Access Compliance Report

Public Rights-of-Way

(Curb Ramps)

Intersection ID: 23386	Main Street: ALEXANDER_RD	Cross Street: BENNING_WOOD_DR	Location: SW
ADA ID: 737C1F329291	Ramp Type: Directional1	Initial Pass/Fail: Fail	Overall Compliance: No
		Severity Score: 1.25

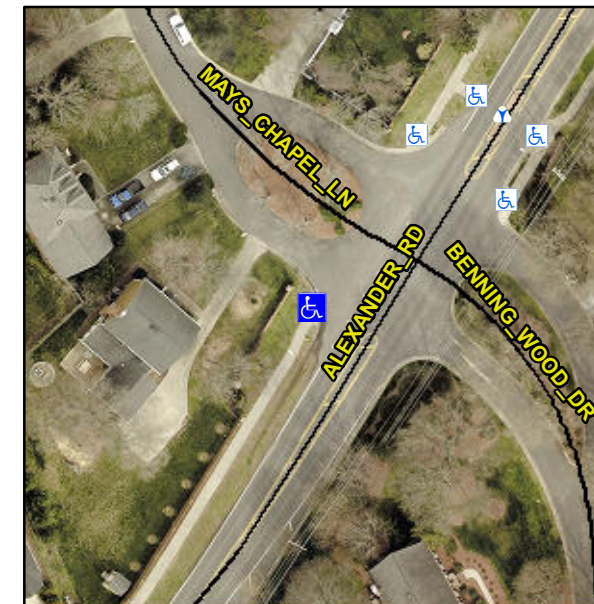
R304.5.3

Remove & Replace Entire Ramp.
